Primary Engineering, Inc.
2828 Lake Ave.
Fort Wayne, Indiana 46805
260-424-0444 ph
www.primary-eng.com

Addendum: **1**
Date: **3/7/2025**
Project: **FWCS HPB Natatorium HVAC Improvements**

Comm #: **24634**

SHEET:
M202

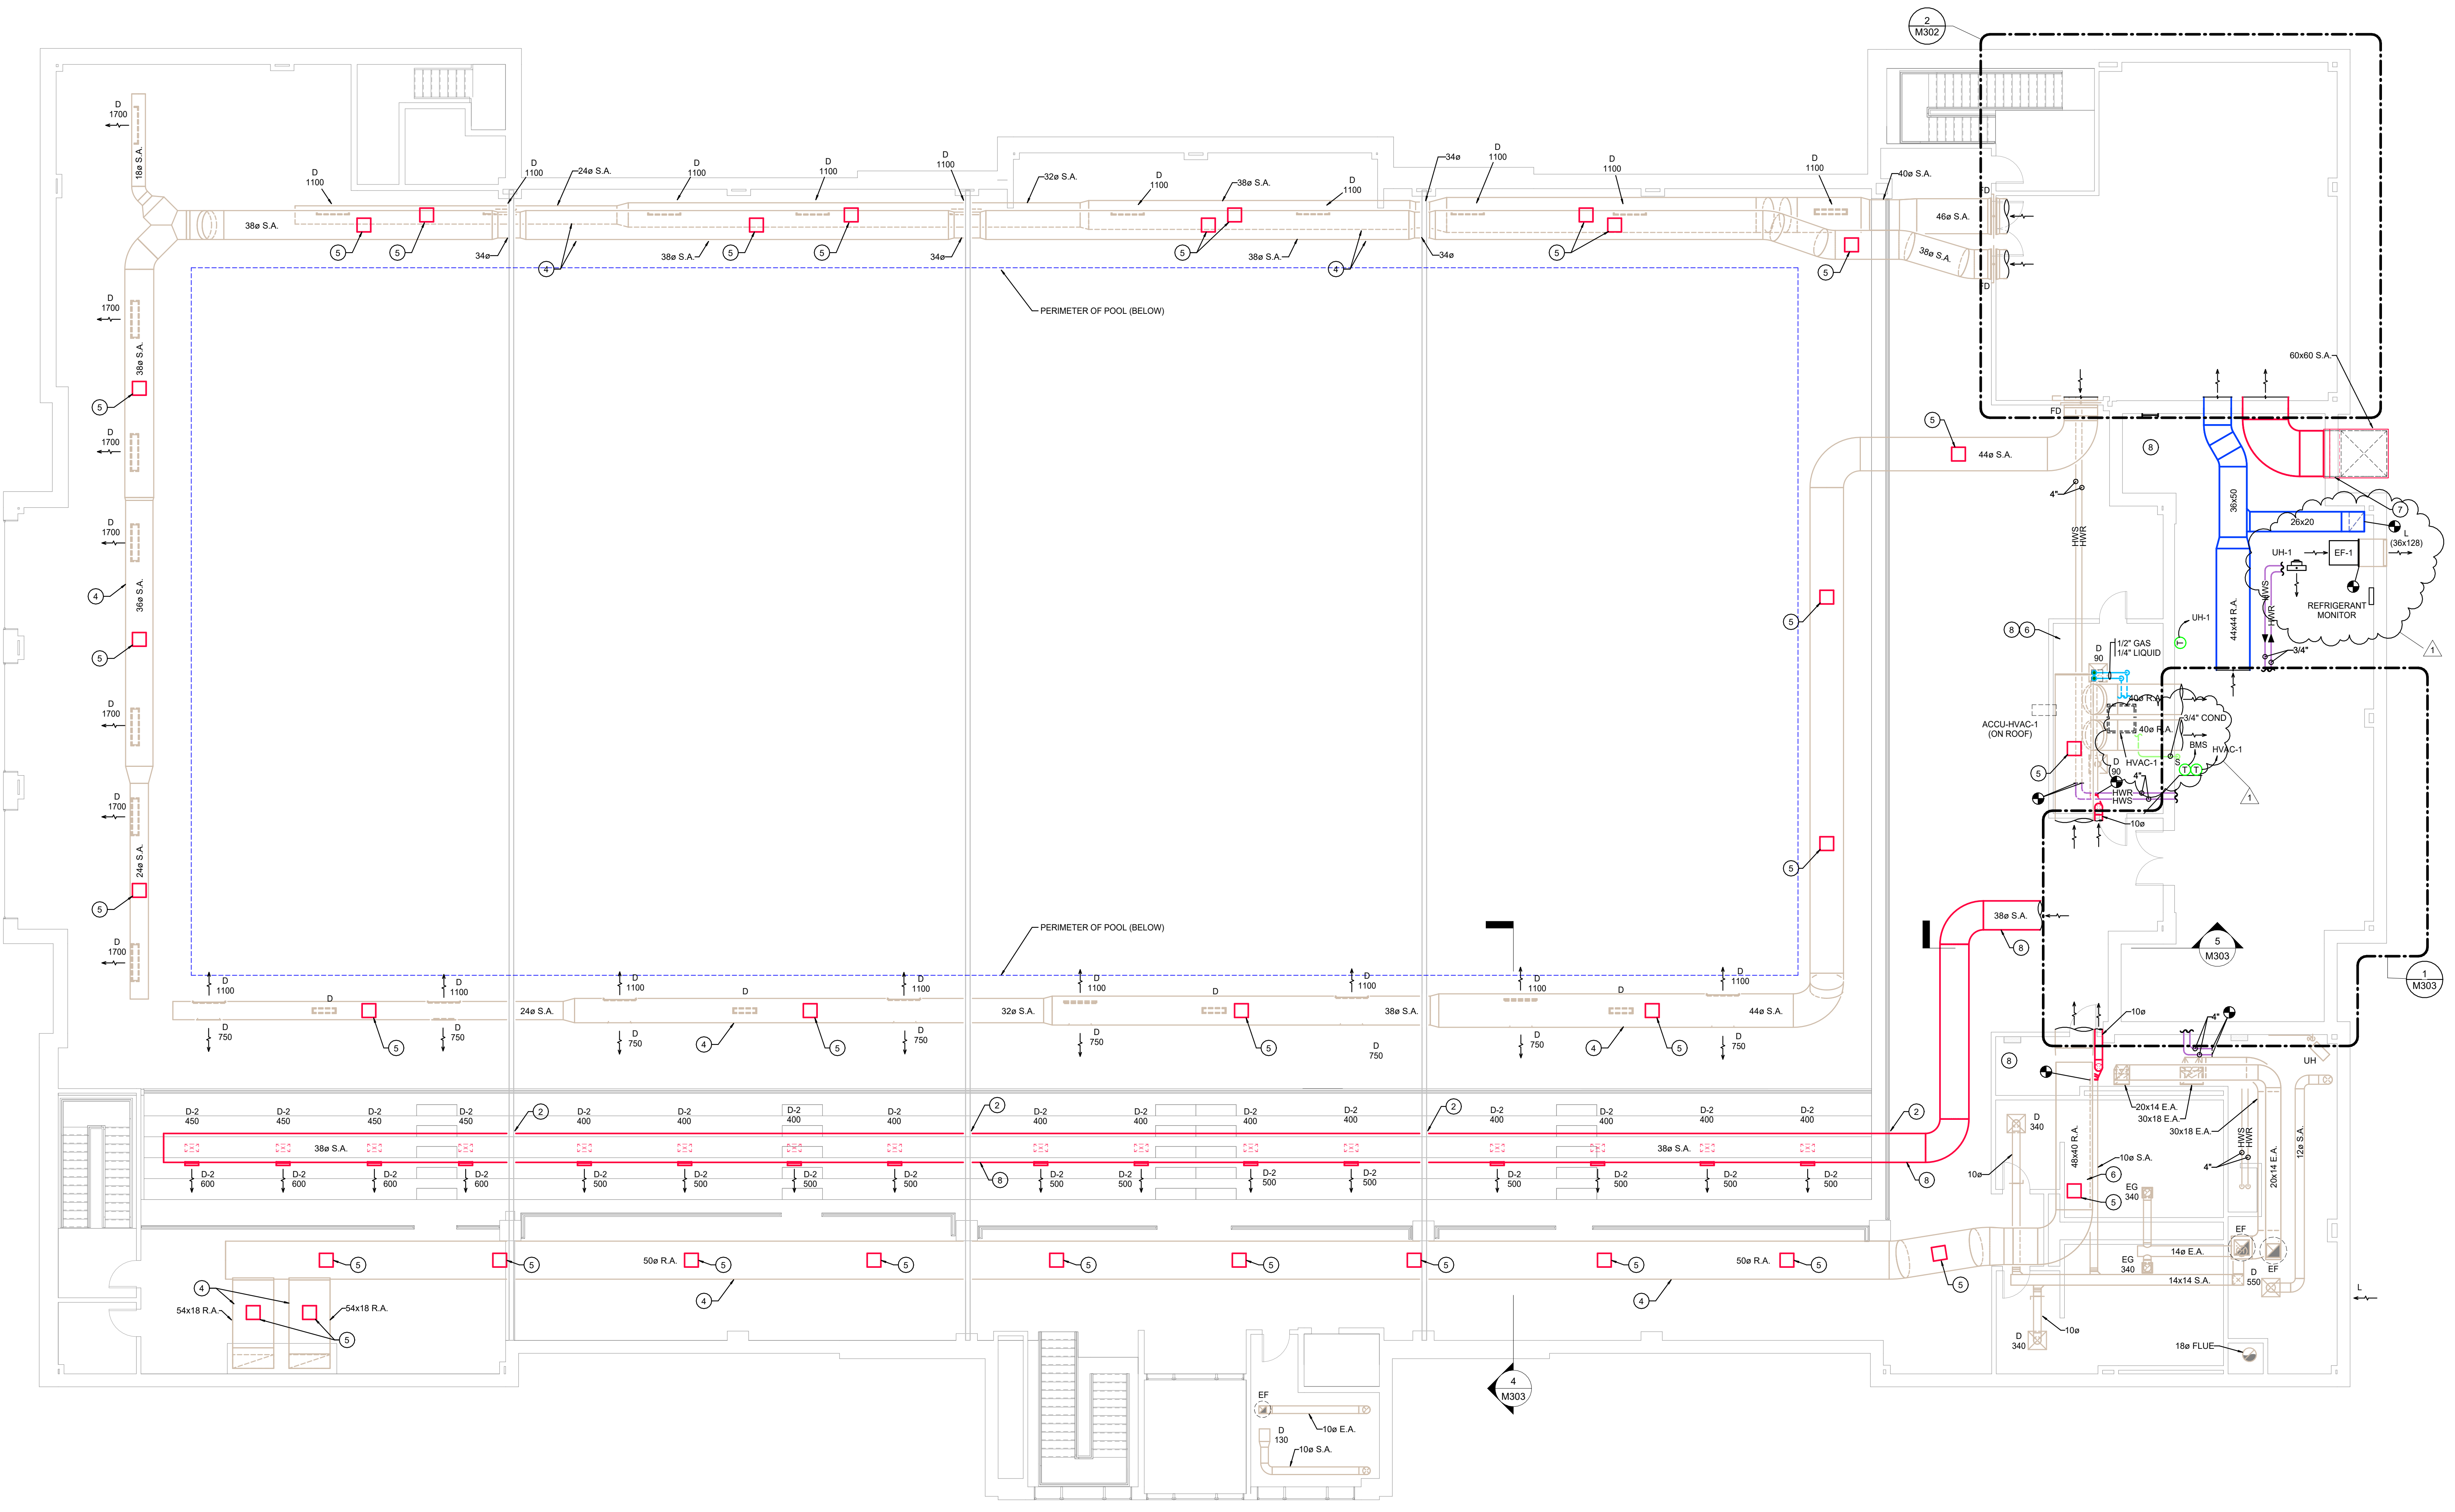
- A. Add refrigerant monitoring and exhaust systems. Add condensate piping to HVAC-1. See attached drawing revision to M202 dated 3/7/2025.

SHEET:
M203

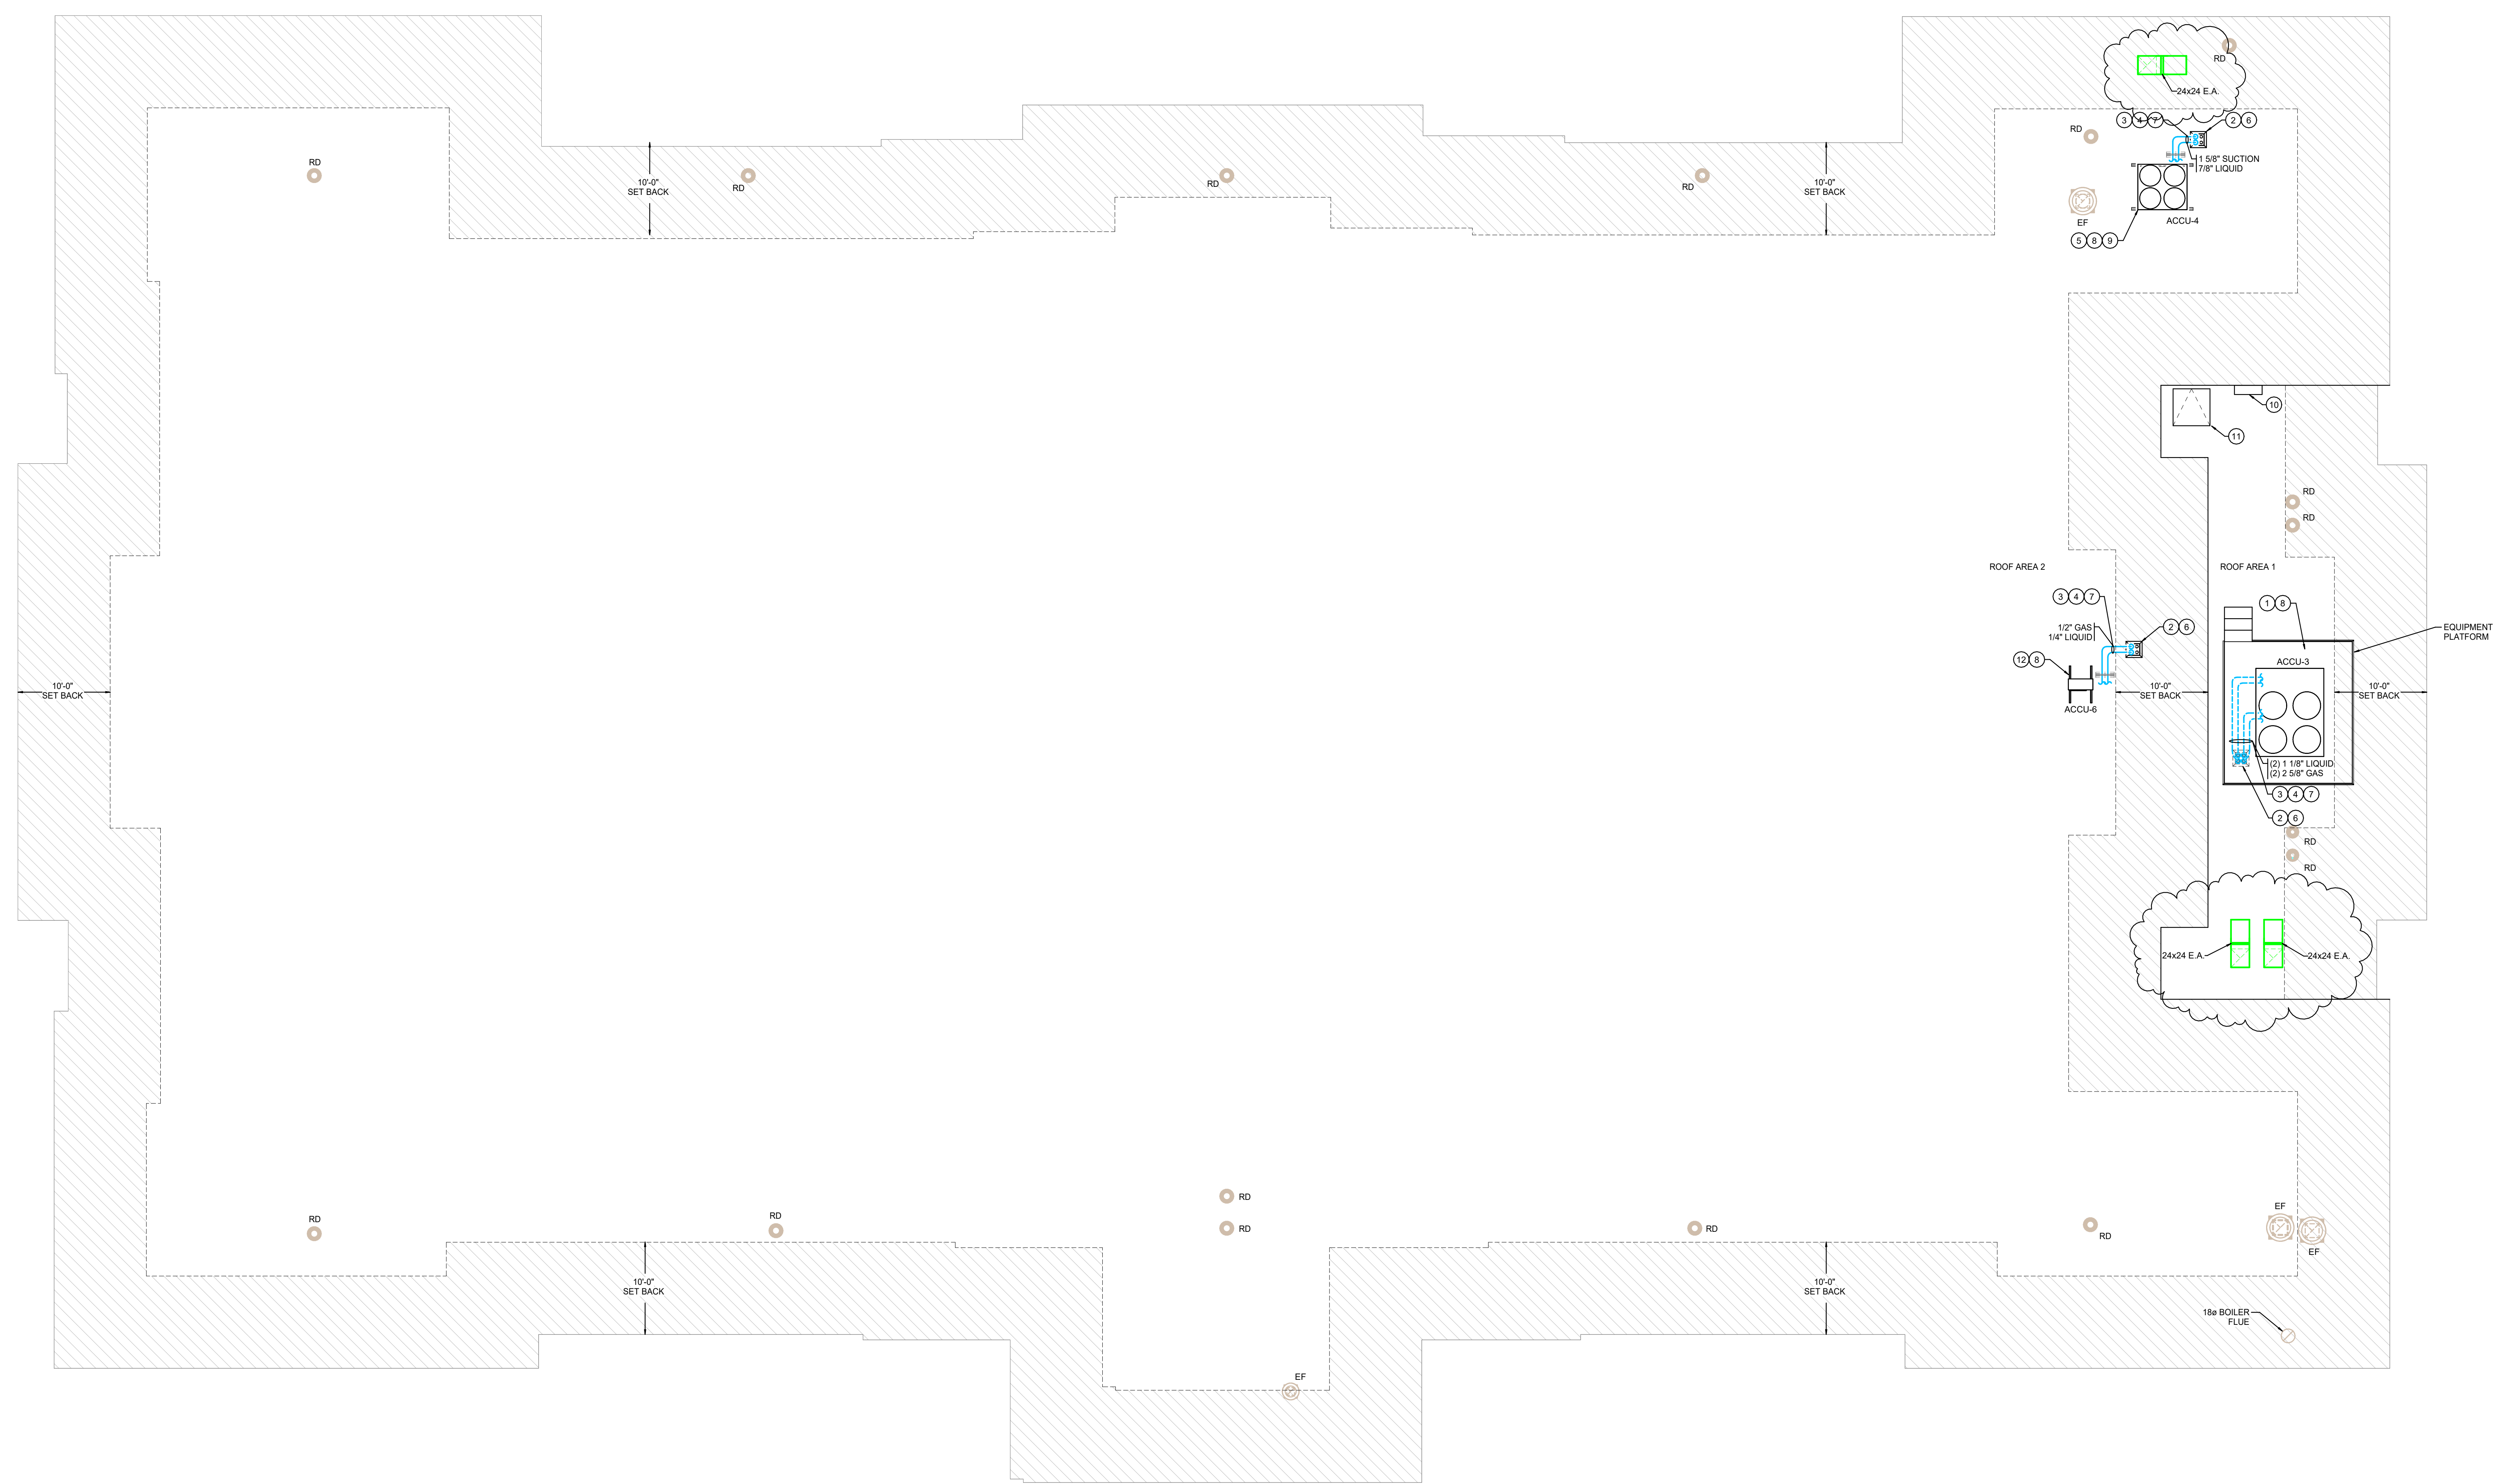
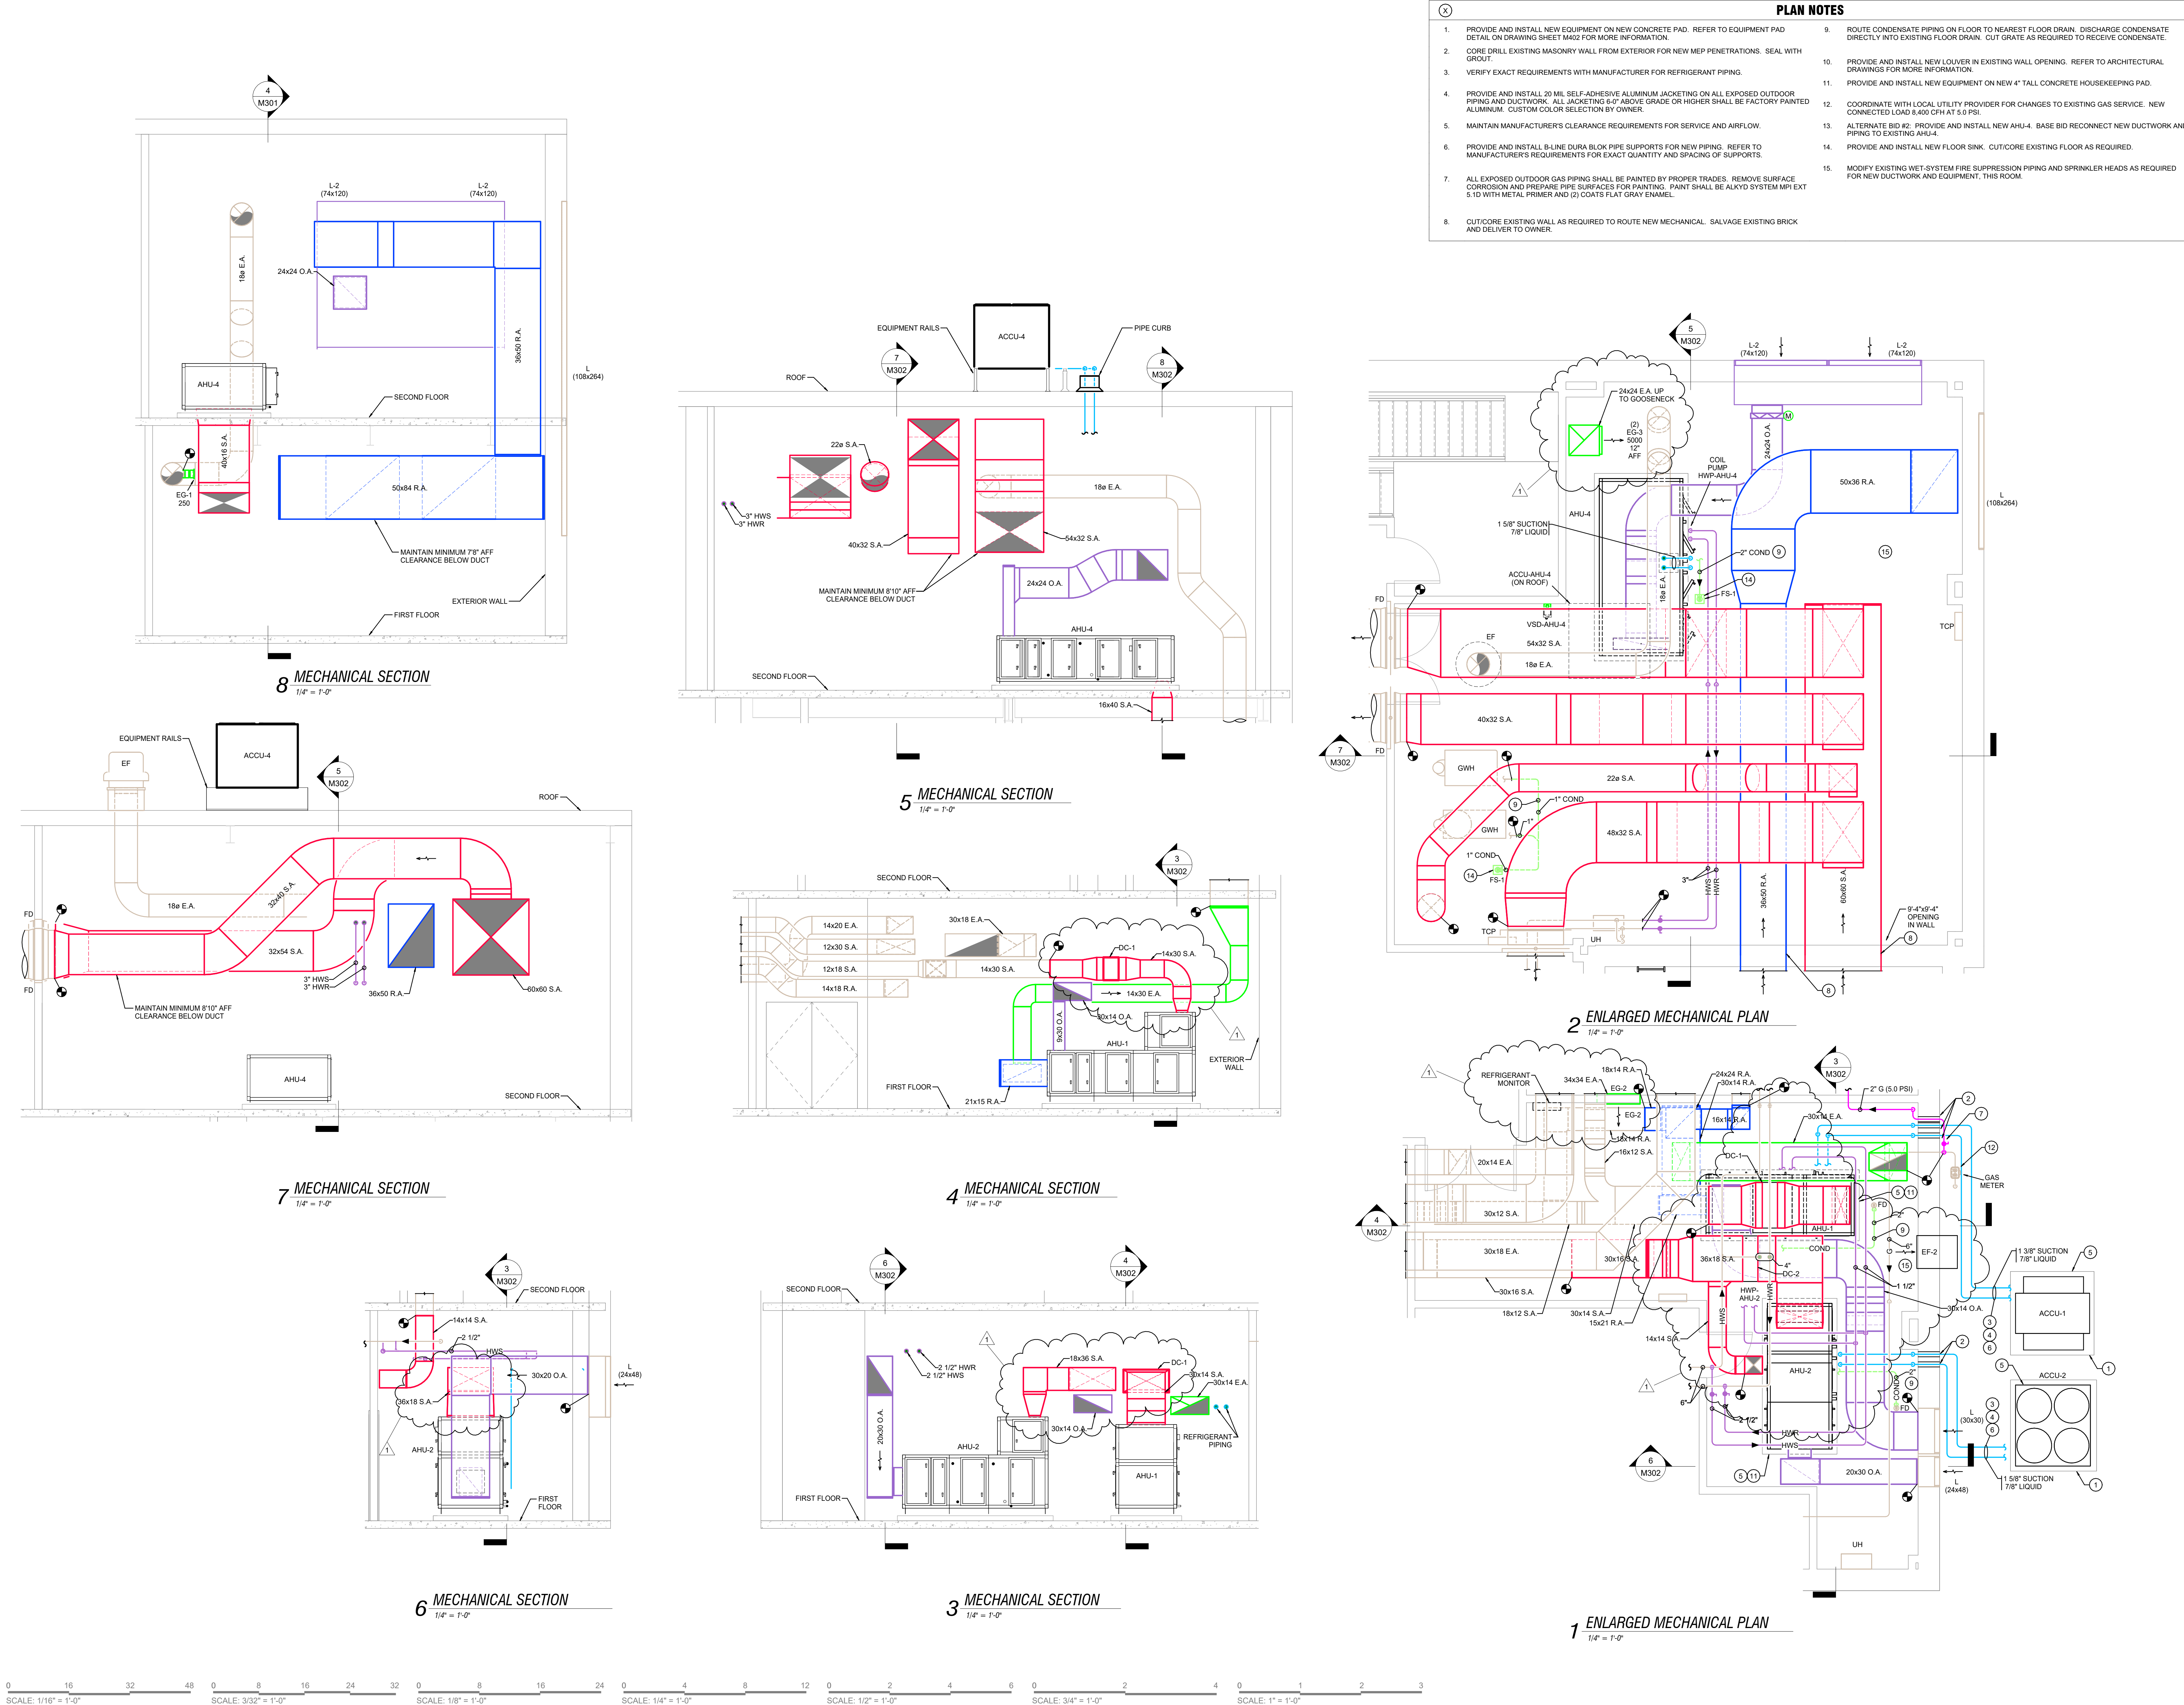
- A. Add gooseneck intakes for refrigerant monitoring and exhaust systems. See attached drawing revision to M203 dated 3/7/2025.
